Project #21-064
Cache County Food Pantry
Located at 359 South Main Street

Project Name: Cache County Food Pantry
Proponent/Owner: Courtney Wallace / Cache Community Food Pantry Inc.
Project Address: 359 South Main Street
Request: Design Review Permit
Current Zoning: Commercial (COM)
Date of Hearing: October 28th 2021
Type of Action: Quasi-Judicial
Submitted By: Russ Holley, Senior Planner

Staff recommends that the Planning Commission **conditionally approve** a Design Review Permit for Project #21-064 Cache County Food Pantry, for a new 9,240 SF building located at approximately 359 South Main Street, TIN# 02-052-0029; -0001.

SITE PLAN

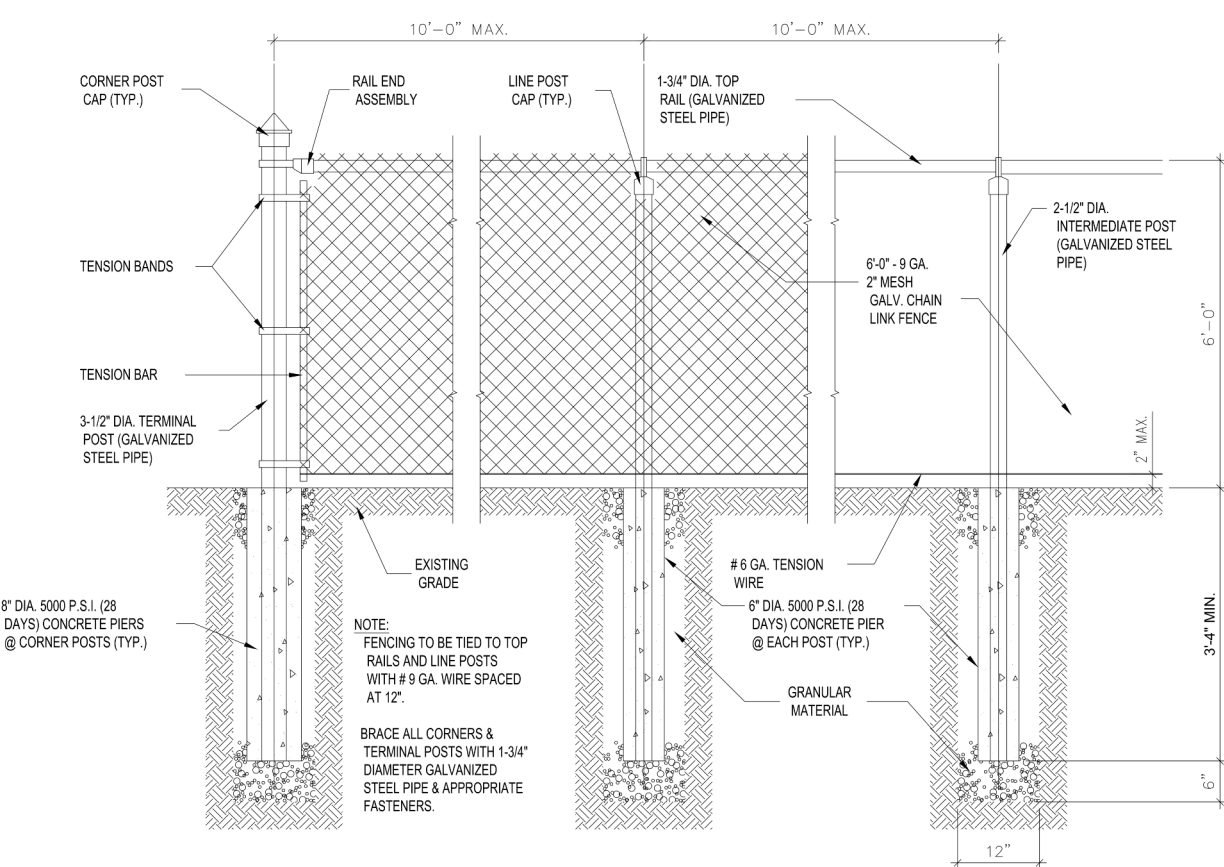
To prioritize architecture and curb-appeal, the LDC 17.10.080 typically requires buildings placed in highly-visible primary positions with things like parking lots, drive-thru windows, utility and loading dock areas in subordinate less-visible positions. The proposed project places this subordinate building behind the existing main building along Main Street with some additional parking and a new driveway to the south connecting to 400 South.

Front: (East)	40'
Side: (South)	45'
Side: (North)	10'
Rear: (West)	10'
Parking (side & rear)	5' & 0'

The LDC 17.30.160 requires pedestrian circulation within a project and connecting to adjacent public streets for better walkability. Pedestrian circulation should provide a safe, convenient and well-connected sidewalk/pedestrian network. The proposed project does not show any pedestrian circulation. As conditioned with pedestrian connections to the main building and Main Street, the project meets the pedestrian circulation requirements in the LDC.

The LDC 17.10.080 requires 10% open space and an additional 10% useable outdoor space of the project site in the COM zone. The LDC 17.28 generally describes open space as native vegetation or landscaping areas, while useable outdoor space is typically decks, patios and other similar amenities. The approximate 0.54-acre (23,522 SF) site would require 2,352 SF of open space and 2,352 SF of useable outdoor space for a total of 4,704 SF of open area. The proposal shows conceptual open space. As conditioned with minimum open space requirements, the project complies with the LDC.

3. The proposed new driveway shall be 24 feet wide max with minimum 5-foot setbacks on both sides. Curb cuts on 400 South may be wider to accommodate large truck turning radius.

4. A solid fence (no chain link) and landscape strip 10 feet in width planted with threes and shrubs shall be installed along the west boundary adjacent to the single-family home at 47 West 400 South.

ARCHITECTURAL
ELEVATIONS
A201

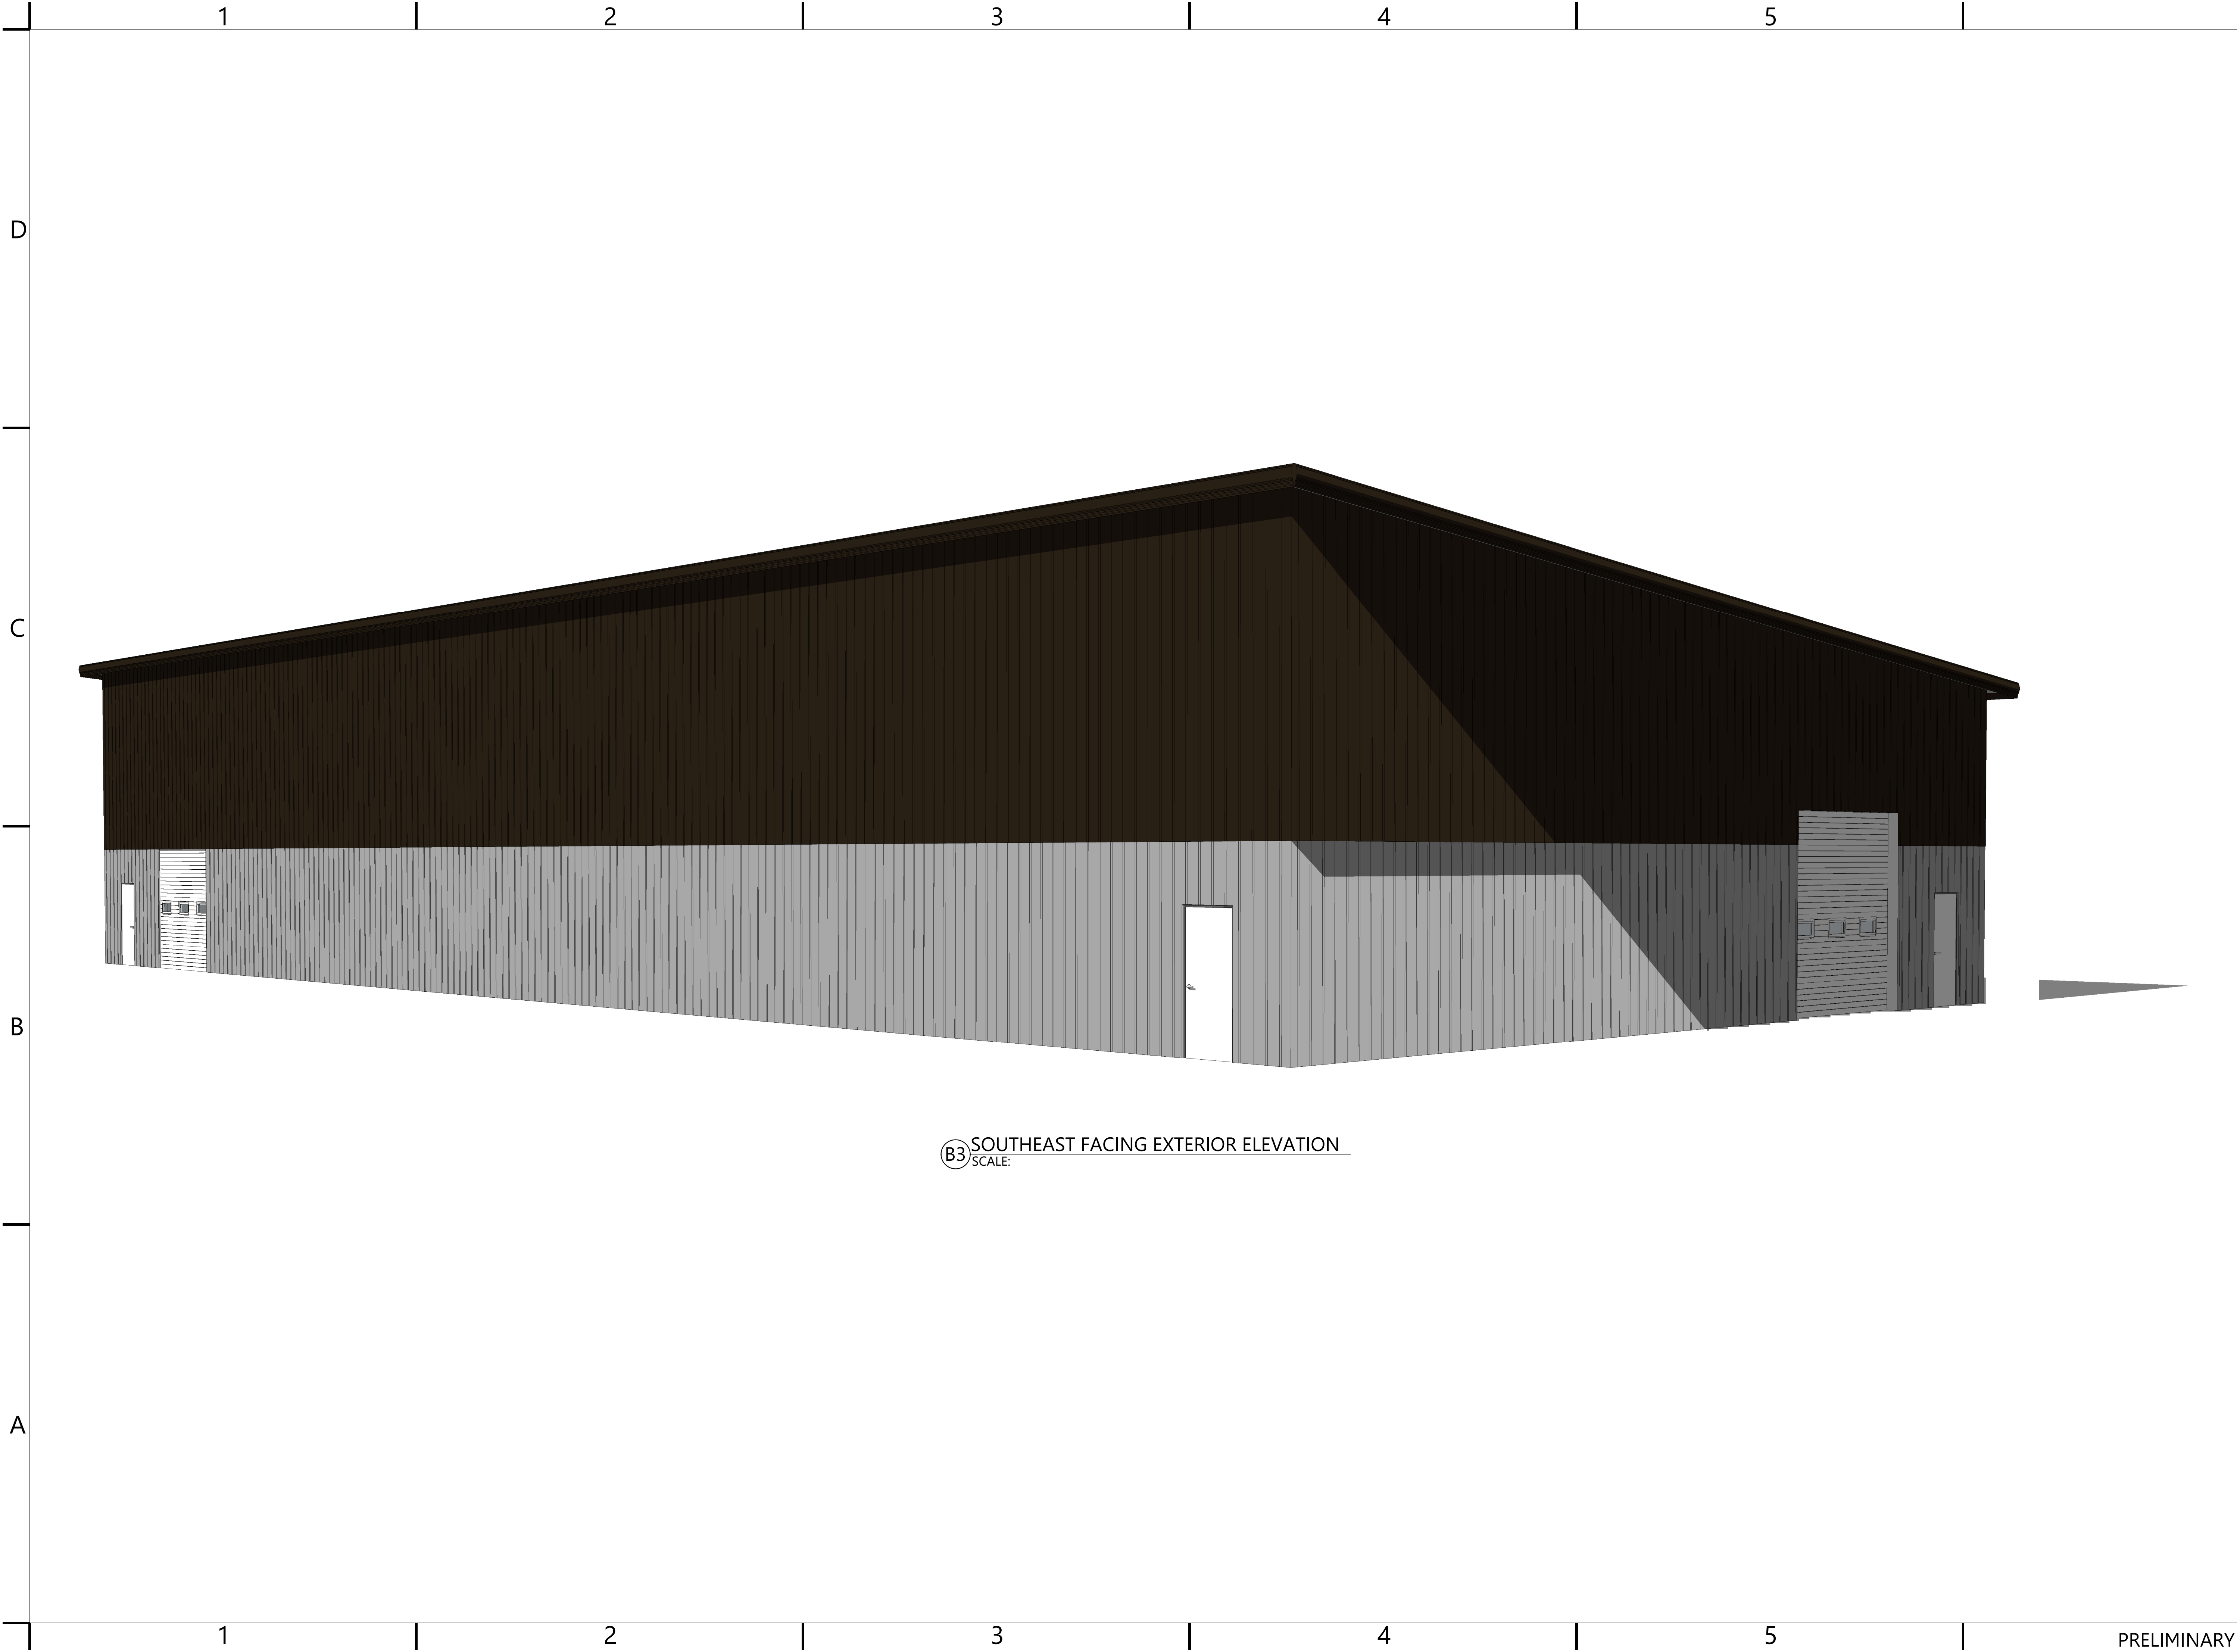
The LDC 17.10.080 states that commercial buildings should be designed to promote high- quality developments with 30% transparency along street facing facades, walls breaks/articulations every 40 linear feet and inviting four-sided architectural design. The proposed metal warehouse building does not have street facing facades and does not show any wall articulations. The building does show a color break halfway up the wall around the entire building. If the color changes are deemed acceptable wall breaks, the building design complies with LDC standards as proposed.

8. The Planning Commission considers the color changes acceptable breaks in the building design because of the location and use of the building. The street facing 30% fenestration requirement is not applicable on this portion of the site.
